Planning Commission Study Session

TO: PLANNING COMMISSION / DESIGN REVIEW BOARD

SUBJECT: DR18-145, SANTAN PAVILIONS PHASE VII ASHLEY
FURNITURE HOMESTORE

EXTERIOR ELEVATIONS

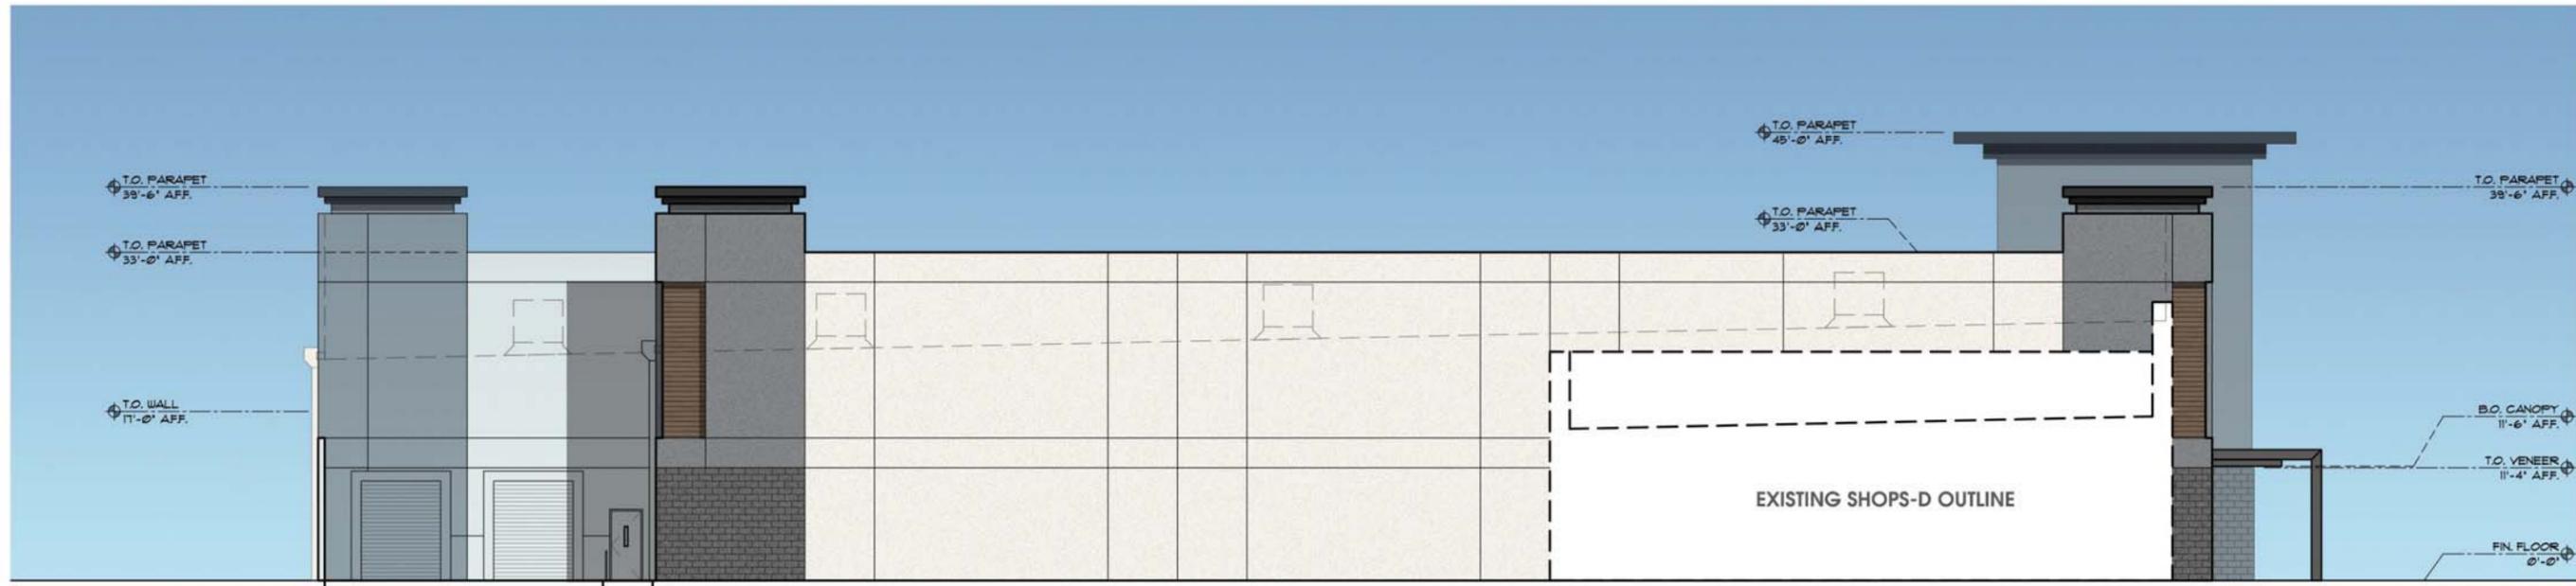
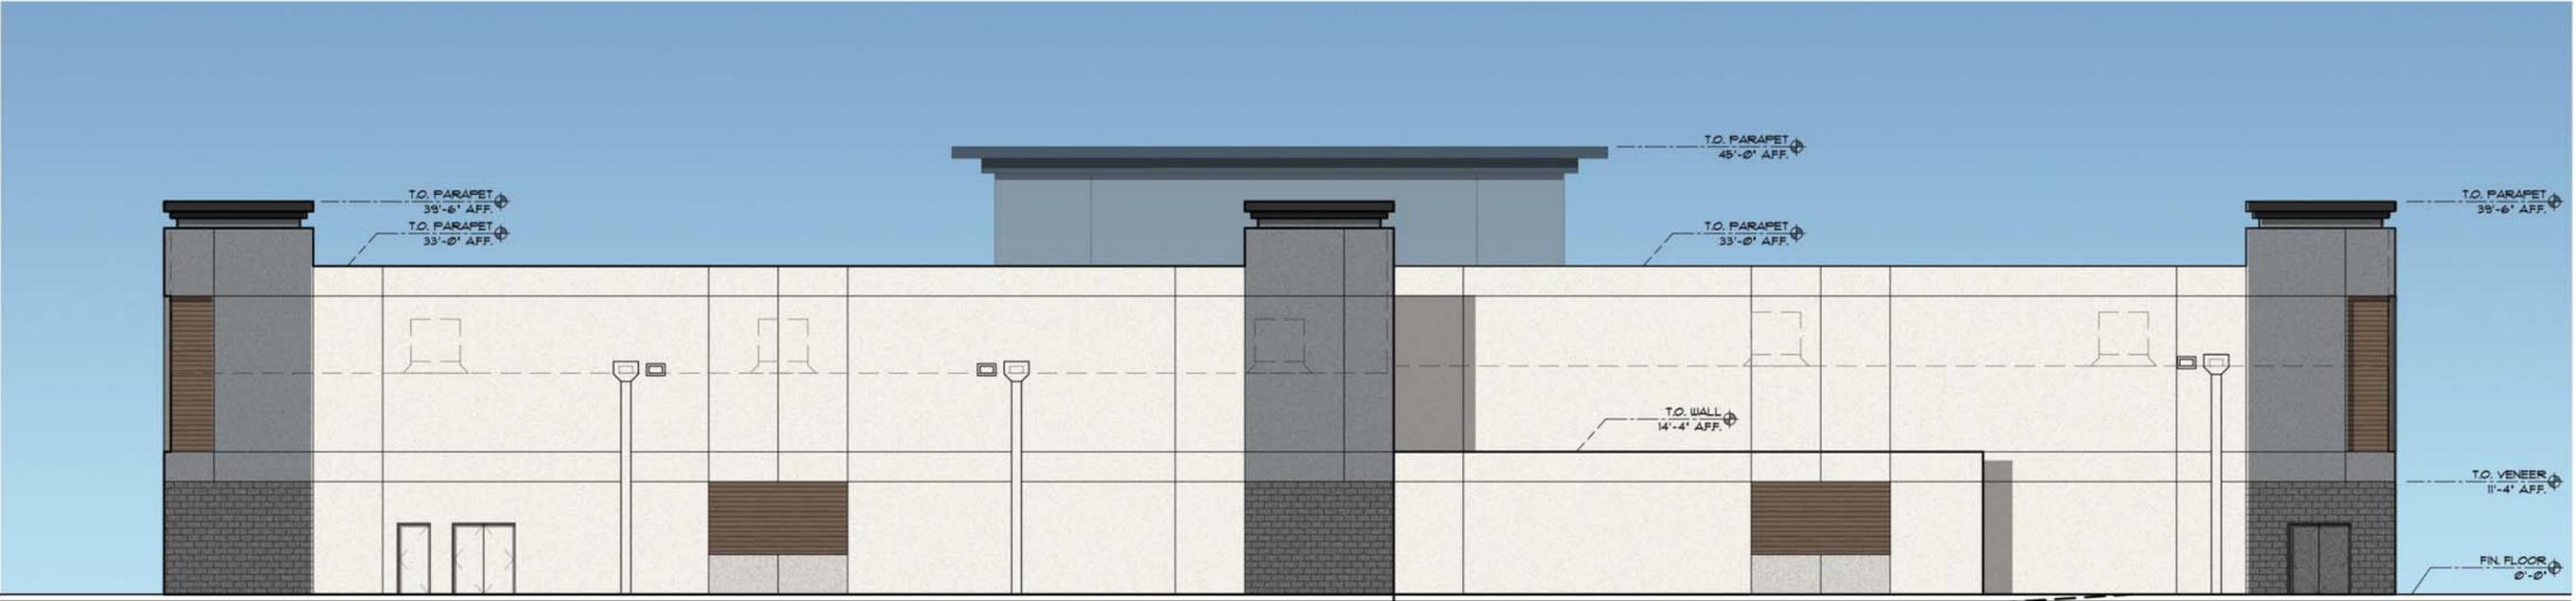
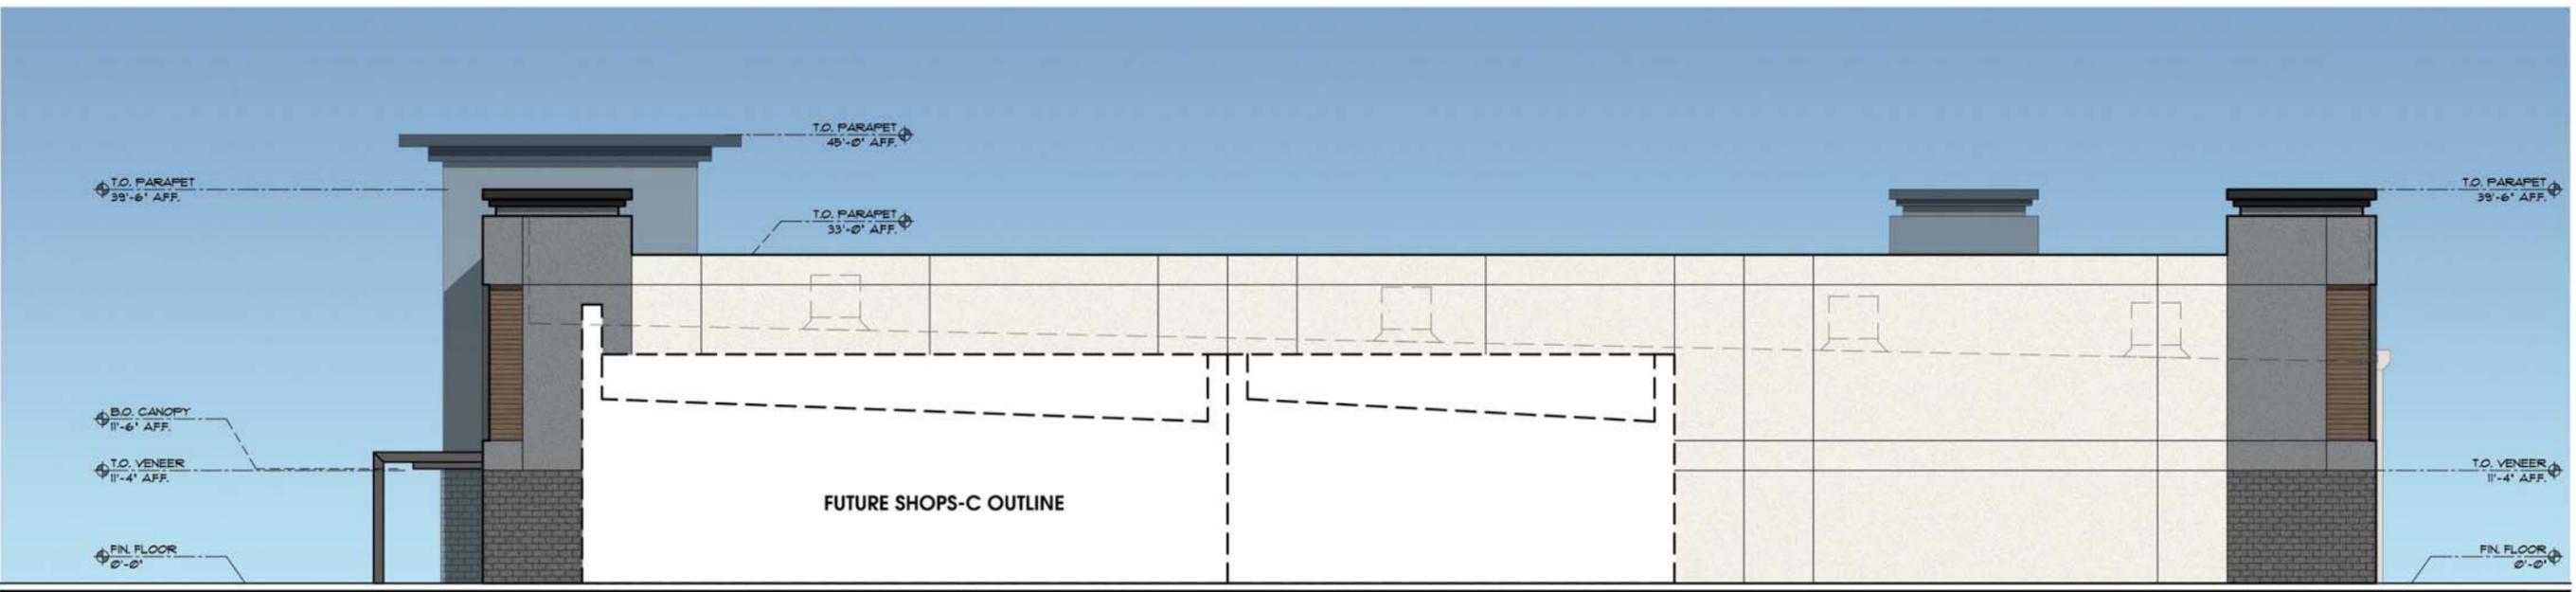
The colors and materials are consistent with previous approvals in Phases I-VI. The architecture is developing with a sophisticated, family friendly character appropriate for the Gilbert shopper. The design motif sets a stage for multiple tenant identities within an organized framework of materials and forms. Though there is no strong reference to historical style, the building designs nonetheless embrace many timeless qualities that appeal to human interaction and scale. The

building east and west elevations will mostly be covered by Shops C, D and Major B (At Home) resulting in less articulation. The south elevation does incorporate all materials staff is requesting further articulation and requires all drainage must be internalized. A shaded canopy will be provided along the store front on the north elevation consistent with the rest of the buildings in SanTan Pavilions. *First review comments include further articulation to match the architecture blocking style with the rest of the center, examples of recent approvals have been attached.*

1. Articulation and building massing compared to architecture approved within SanTan Pavilions
